UHCC - PC42 Hearing

Pinehaven Stream – Flood Mapping Audit 2015

Save Our Hills (Upper Hutt) Inc.

Michael Law, Auditor, Beca Report, 13 July 2015, p17

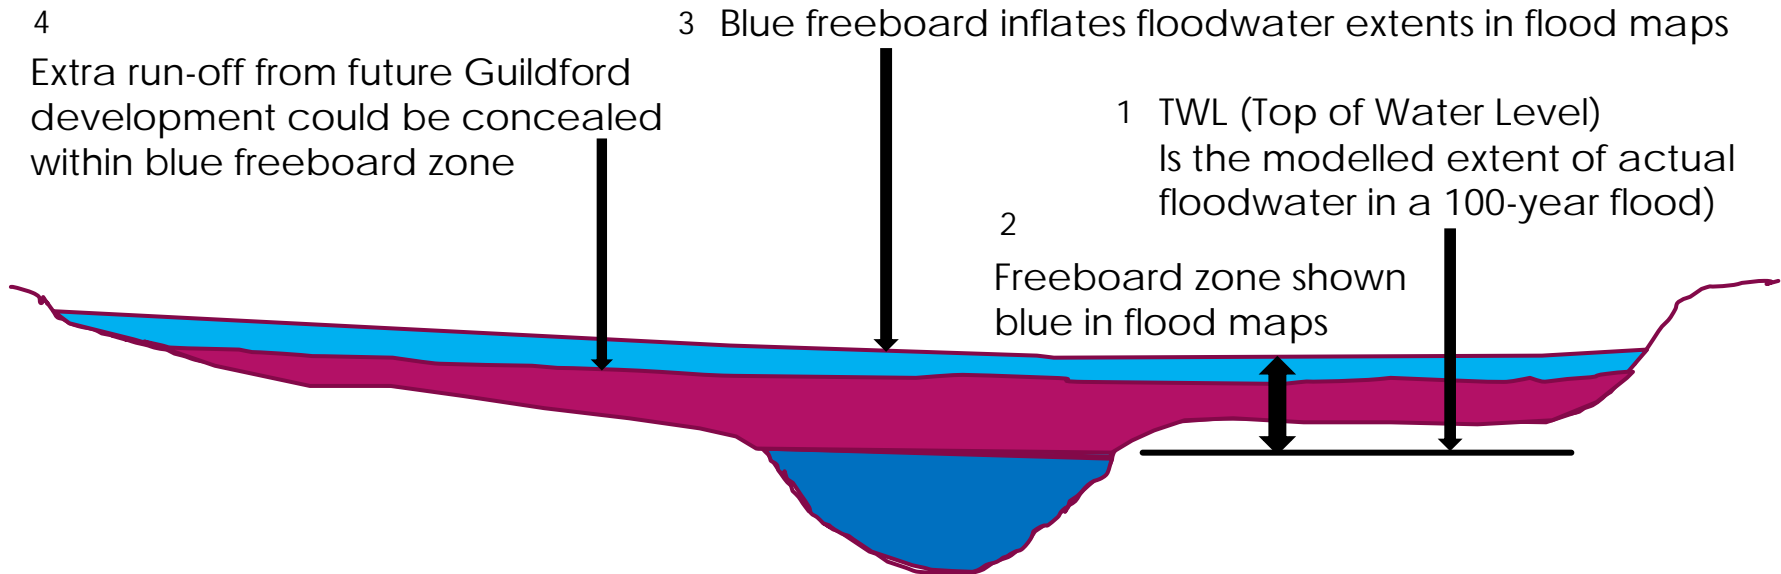
Unsatisfactorily, the 2015 audit suggests... extra run-off from future development can go in the blue freeboard zone without materially affecting the flood maps

"the effects of future development on flood extent are not modelled correctly. However... because there is freeboard incorporated into the results, the flood maps are unlikely to be materially affected by this apparent anomaly."

Is this why HVFMS (GWRC, HCC and UHCC) and their experts and consultants have insisted all along that freeboard must be modelled as floodwater, to accommodate future run-off from the Guildford development?

Figure 5.2 Flood extent elements

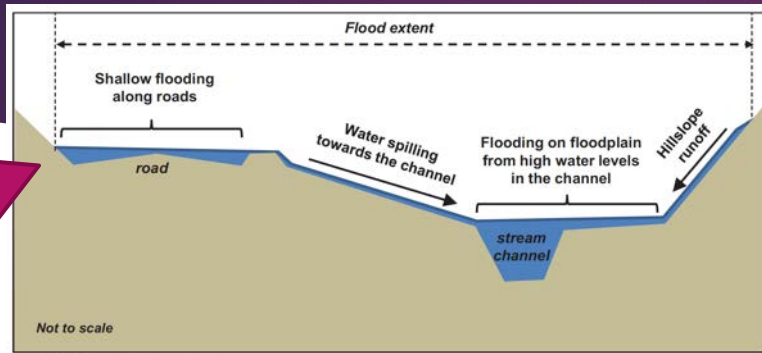
Similar situations to that at Elmslie Road occur at the other three locations identified by SOH's case studies.

The auditor's tale about 27 Elmslie Road [and 3 other cases*] (shown in the auditor's diagram above)

Tampered data:

1. There is no flooding on Elmslie Rd at No. 27 (see GWRC flood map for 27 Elmslie Rd on PC42 Hearing Slide 3.22)
2. Before audit Water on berm is separate from water in channel (data on GWRC graphs, top right of slide).
3. After audit Higher ground removed from berm and berm water shown flowing into channel (altered data, graphs bottom right) to fit the tale in the diagram above.

*Two of the other case studies are NOT like the one above (Dunns St and Pinehaven Reserve) – they're flat. The tale in the above diagram (of water flowing from adjacent hillsides across the property and into the stream) doesn't explain why Dunns St and Pinehaven Reserve flood extents are so wide (and deep) - PC42 Hearing Slides 4.4 & 4.6

How to create clearer and more informative flood hazard maps

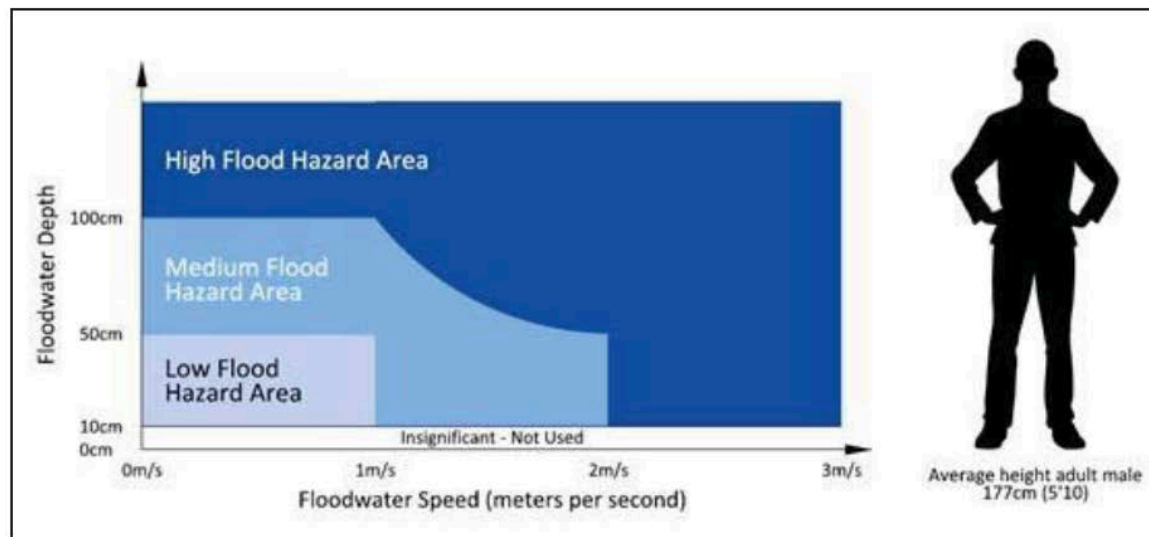
For example, describing the area covered by freeboard beyond the modelled flood extent as a Flood Sensitive Area may be more transparent and more appropriate than GWRC's use of all-encompassing Flood Hazard Areas. Changing the name would allow GWRC to provide true flood hazard maps, based on the combination of water depth and flow velocity at any location. These flood hazard maps can be particularly informative in areas where flood extents are large, but there is also deep or fast flowing water in defined flow paths or depressions. Figure 6.4 shows how flood hazard is defined in Hamilton, while Figure 6.5 shows an example of a flood hazard map from the UK based on similar principles.

GWRC Pinehaven Floodplain Management Plan, Revision 5, 19 February 2016, pp 65-66 Appendix E, Flood Hazard Maps (D X V) = H

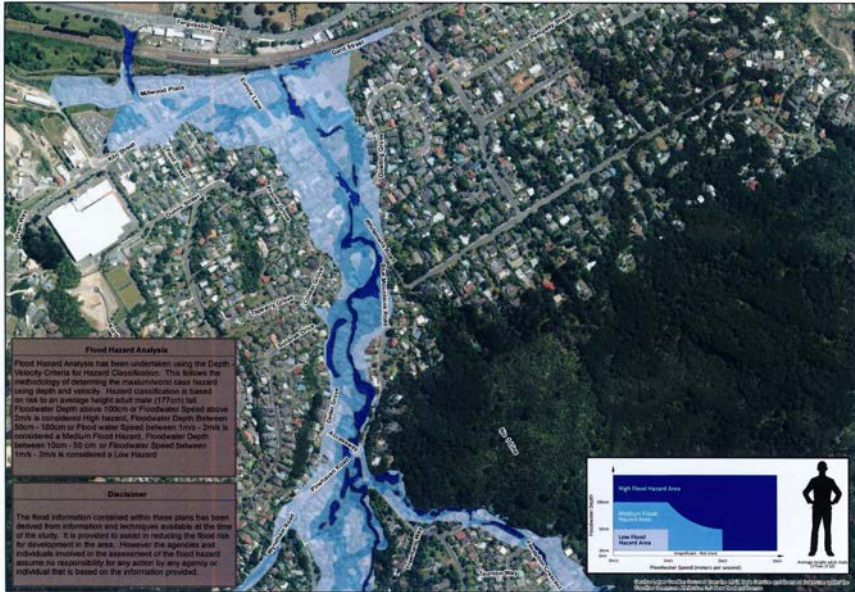
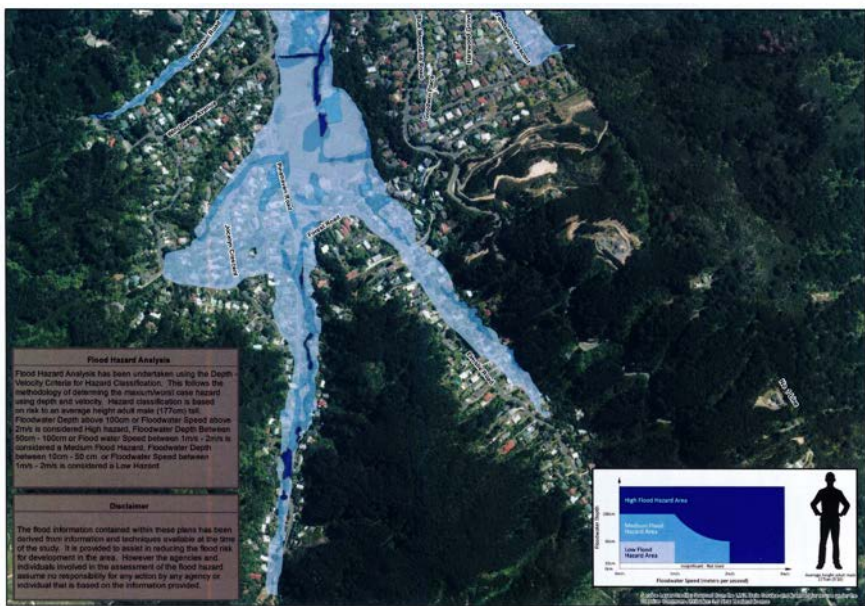
“Flood hazard maps often show the flood hazard calculated as a product of the flood depth and water velocity. This is useful from a hazard assessment perspective to understand potential danger to people, and can be readily calculated from the outputs of 2D hydraulic models. ... such a map would not show any hazard in the buffer zone between the modelled flood extent and the extent including freeboard.”

The flood maps opposite, although using the NSW method, are flawed (Slides 5.6 and 5.7). Assuming the outputs of the flood model are correct (check), rectify the “major issue” by:

- removing blue shading of freeboard
- removing actual water depth <10cm

Resulting flood extent will be less and represent the ‘current situation’ for comparing hydraulic neutrality of future developments (check).
